COS2010 MANUAL ADDENDUM

This addendum applies only to units manufactured after March 25, 2002.

3 Wire Interconnection

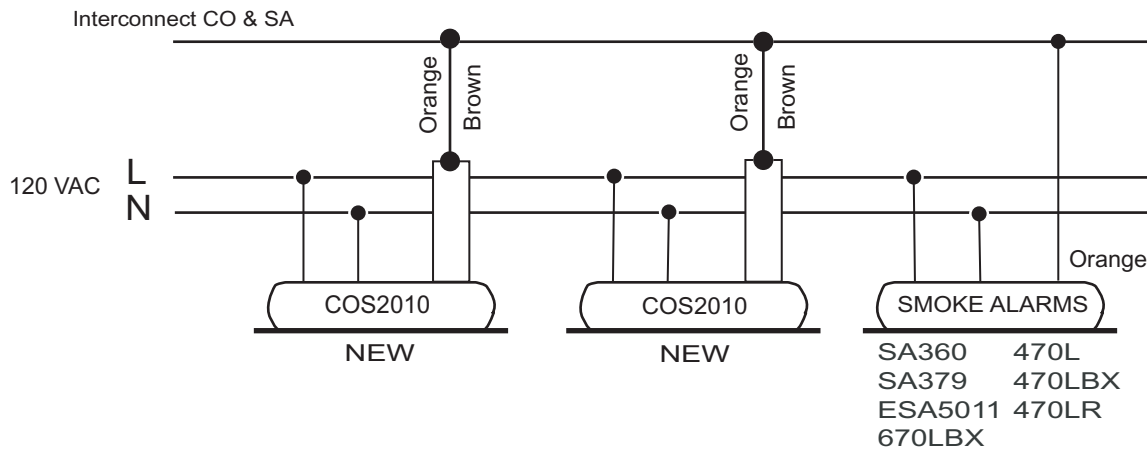
This version of the COS2010 supports a 3 wire interface. This means that the CO interconnect line and the smoke alarm (SA) interconnect line may be connected together and interconnected with compatible CO and smoke alarms. COS2010 units manufactured prior to March 25, **DO NOT** support this form of interconnection of the CO and smoke functions.
